**LEONA QUARRY HYDROLOGIC REVIEW
PHASE TWO**

City of Oakland
Public Works Agency

Philip Williams & Associates, Ltd.

October 21, 2003

Figure 7. Pond 4, Stage - Storage

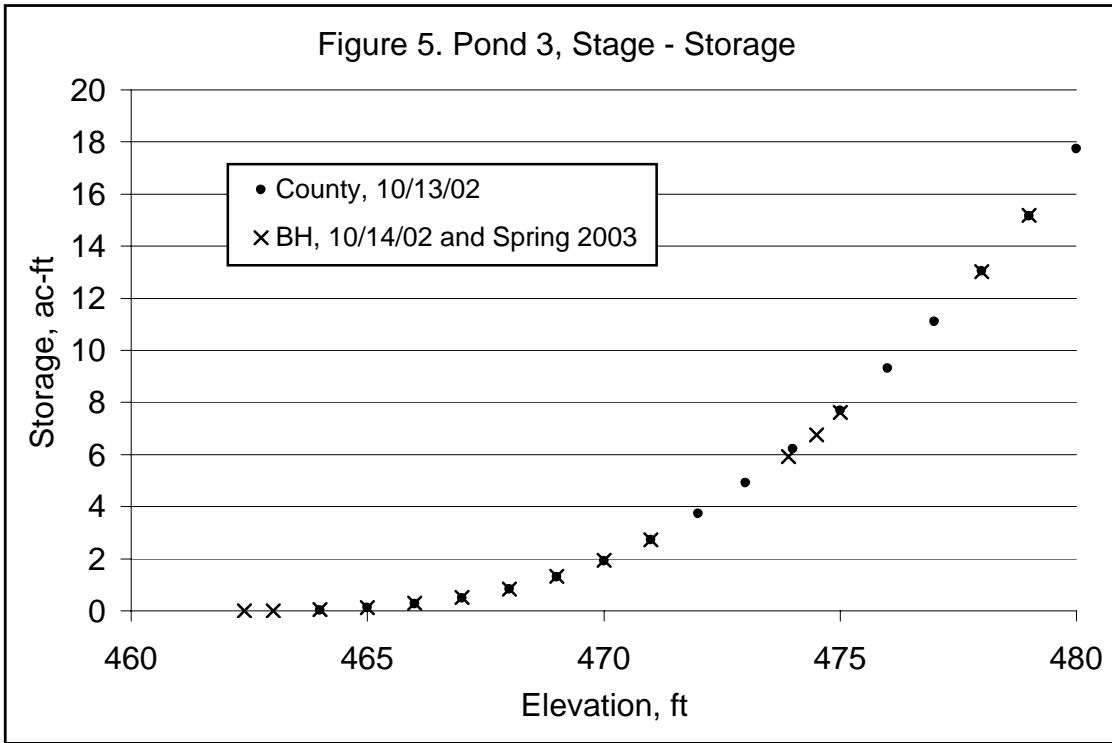
Pond 4 is the existing pond located at the west-central corner of the proposed development site. BH's estimates of the storage volume and associated stage-storage relationship of Pond 4 (Figure 7) appear reasonable based on the footprint of the pond. BH estimates that Pond 4, under existing conditions, has a detention volume of 3.07 acre-feet. PWA generated a stage-discharge relationship using standard equations for pipe hydraulics based on the existing 30-inch corrugated metal pipe outlet and assuming a 15-foot weir spillway if the pond is overtopped. The rating curve generated by PWA approximately agrees with that used by BH (Figure 8).

Figure 9. Pond 4, Proposed Conditions, Rating Curve

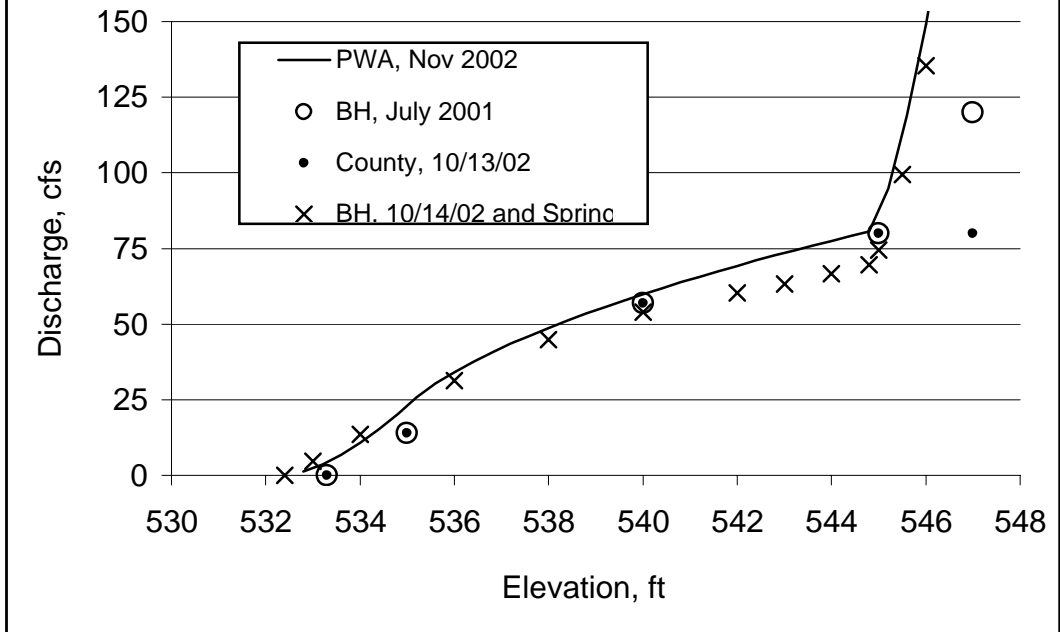
Under the current development proposal, Pond 4 would remain and the Pond 4 outlet works would be improved. BH estimates that Pond 4 improvements would result in a slight detention storage increase, from 3.07 acre-feet to 3.15 acre-feet. BH models the outflow under proposed conditions assuming a single drop box (the perimeter would be comparable to that of a 36-inch riser) with one rectangular orifice (2.75 ft x 2.00 ft). BH's model assumes that all flow up to and including the 100-year flow would pass through the new drop box. Given the outlet dimensions specified by BH for future conditions, PWA verified the Pond 4 rating curve (without spillway) for the developed scenario (Figure 9). It should be recognized that the existing 30-inch outlet pipe would not have the capacity to handle the flow from the proposed 36-inch riser/orifice structure. BH reports that the applicant plans to replace this pipe with a 42-inch pipe, which appears adequate. PWA assumes that the proposed riser/orifice structure would dictate the limit of outflow and, as such, existing Pond 4 outlet structures, including the existing 30-inch outlet pipe, would also be replaced as necessary. This was required by Condition of Approval 23, and is consistent with standard engineering practice, and would be expected to be imposed as a condition of project approval. PWA assumes that the 42-inch outlet pipe would discharge directly to the proposed detention pond (see below), which would further control stormwater flows from Pond 4.
